**REQUEST FOR ADDITIONAL SAMPLING/ANALYSIS
SANTA SUSANA FIELD LABORATORY – RFI GROUP 8
AREA OF CONCERN: BLDG 56 LANDFILL/EXCAVATION AREA
OUTFALL 7**

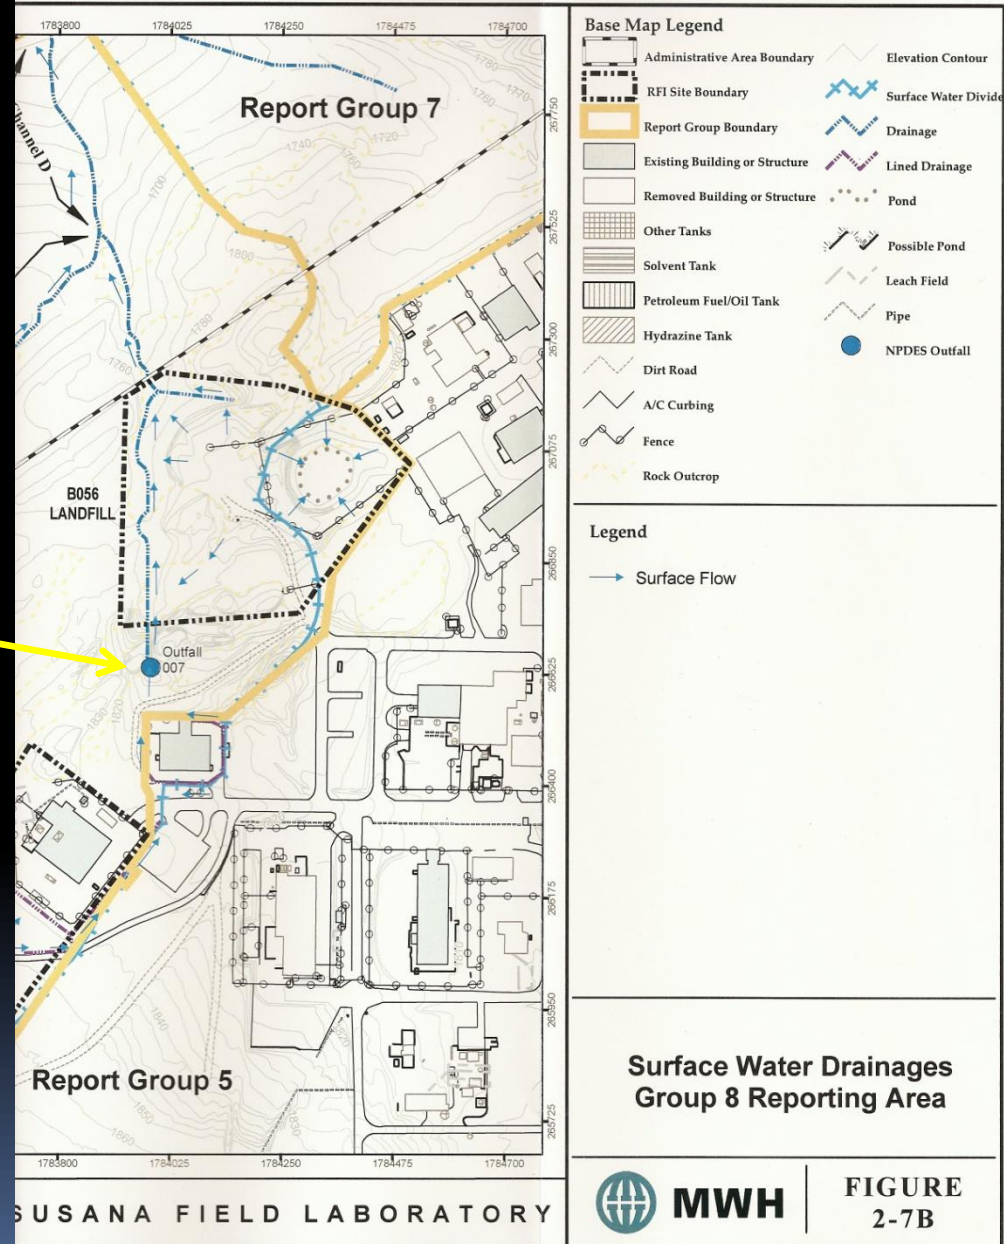
89 Drums of hazardous waste was stored “on top” of the landfill, DOE report states this area qualifies as a potential CERCLA site under DOE order 5400.4

This hole is 50 feet deep and the fill sediment thickness is “unknown”

Location of Outfall 7 is intended, based on bmp structural solution, to deal with water draining from the Building 100 lower slope, but misses all effluent water draining from the Building 100 landfill and excavation areas.

The drums stored on top of the Bldg 56 Landfill area are described as having contained hazardous wastes including reaction products and TCE and other VOCs.

Oil and Grease up to 1100 mg/kg and groundwater impacts in RD7 at 130ppb TCE

Outfall 6 also misses contaminants from ESADA:

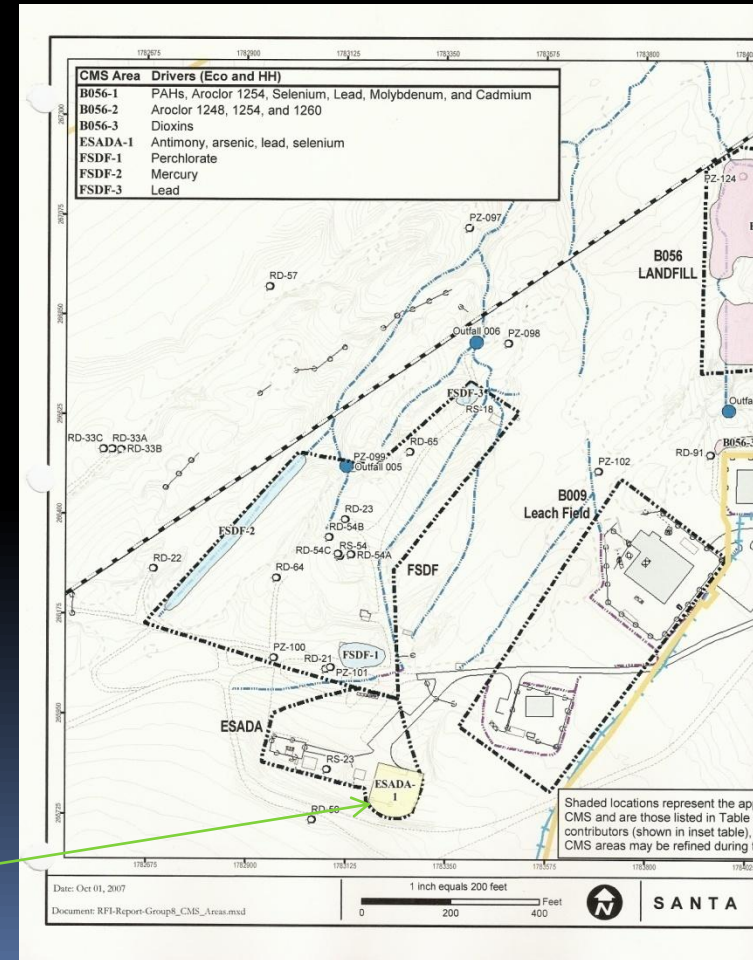
Through the use of drainage culverts, we believe that drainage from the ESADA by-passes the outfall 6 location, going under the road and following the water-divide toward Building 9 leachfield area.

This area shows under-road culvers that direct storm-water runoff:

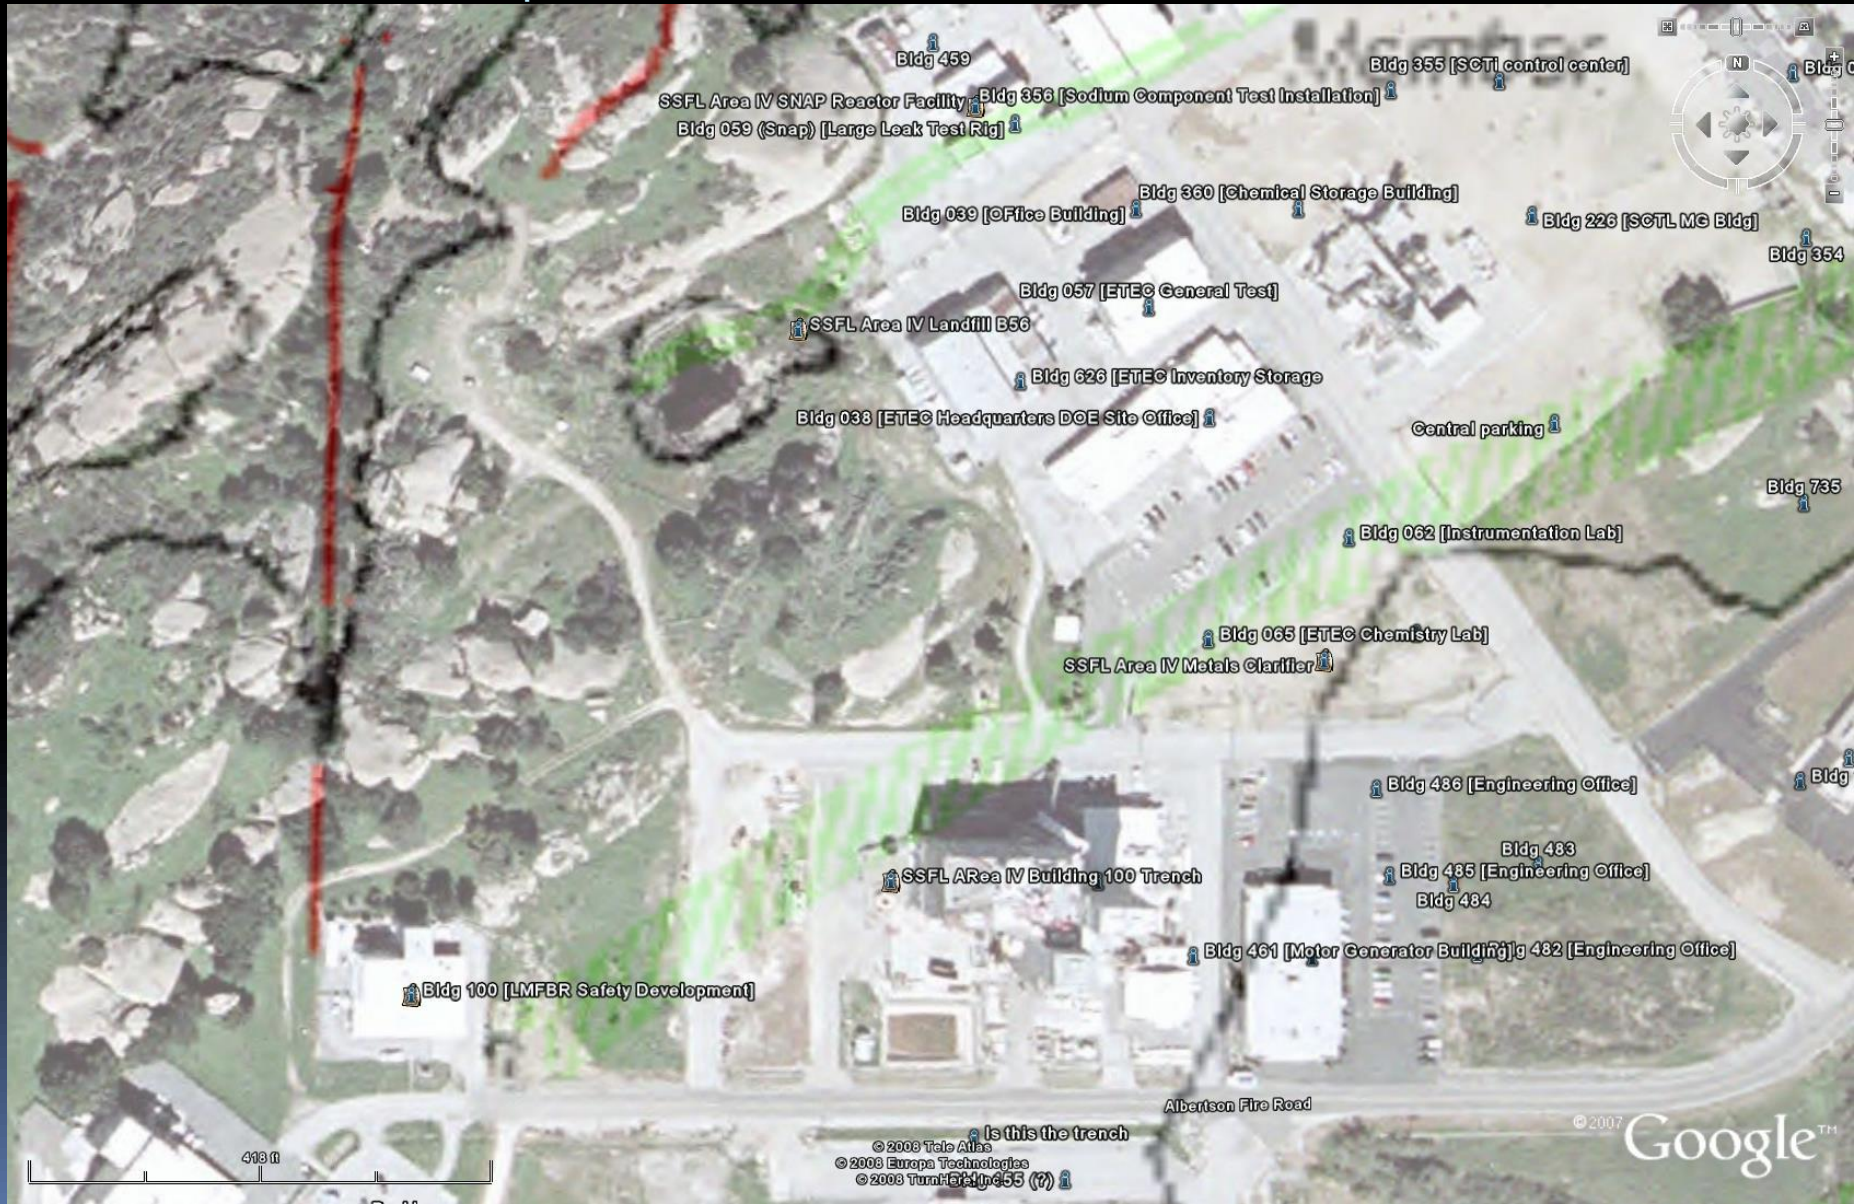
Fault runs from south to north (overlay of Fig 2-5 of known faults shown in red), beginning from Building 100 down the drainage. This area of the B56 Landfill is not showing sampling even though sediment fill was deposited here as well as in the excavation hole.
